MAWLEY HALL: TREE HOUSE

DESIGN AND ACCESS STATEMENT

NON-MATERIAL AMENDMENT APPLICATION FOR THE INSTALLATION OF A CONICAL METAL HOPPER BENEATH THE APPROVED EXTERNAL SHOWER AND FOR A CHAIN CONNECTION TO BELOW GROUND DRAINAGE TREATMENT.

November 2023

Fig. A.1: Approved shower cage and proposed conical hopper at the shower base.

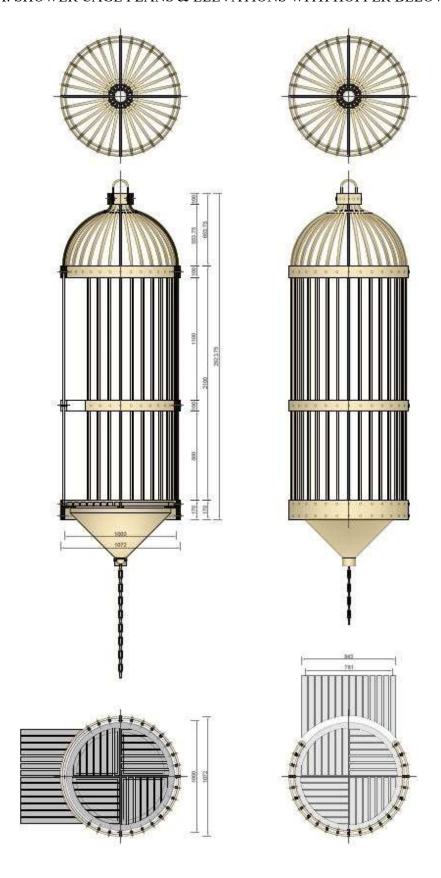
• It is proposed to install conical metal hopper beneath the base slat boarding of the occasional use external shower, that leads to a chain link, connected to the ground, from which the discharge will be connected directly into the below ground local treatment plant.

The conical hopper below the shower cage will be fabricated in brass to match the cage. It is anticipated that the chain will be in painted galvanised steel.
